UNITED STATES PATENT AND TRADEMARK OFFICE

Office Action Summary	Application No. 09/616,214	Applicant(s) MORGAN ET AL.	
	Examiner Sean P. Shechtman	Art Unit 2125

DETAILED ACTION

FIG. 1

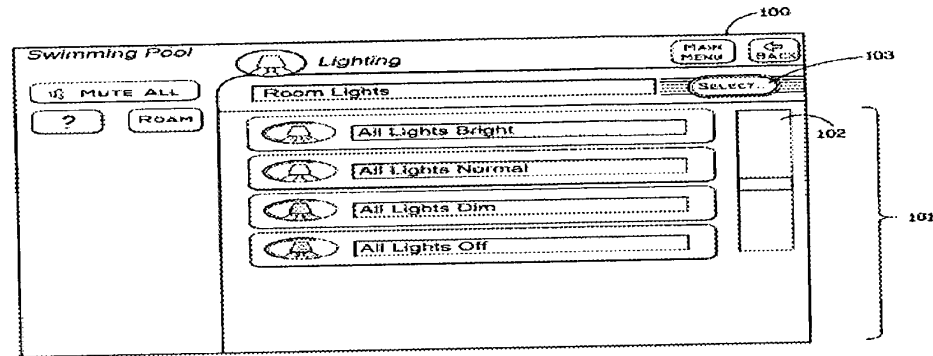
Pyle clearly shows representations of lighting effects on the display of the figure above. Pyle clearly teaches and shows timing control for the lighting effects and lighting units in the scene description table of Fig. 3 and column 5, lines 14-45. In fact, the table is in the form of a grid. Pyle teaches all the limitations set forth above, however, Pyle fails to teach the above table is displayed to the user. That is, Pyle fails to teach displaying grid, wherein the lighting unit is represented at a position along a first axis of the grid, wherein a continuous time interval is represented along second axis of the grid, and wherein a representation of the selected lighting effect during the continuous time interval is displayed on the grid adjacent to the position and parallel to the second axis.
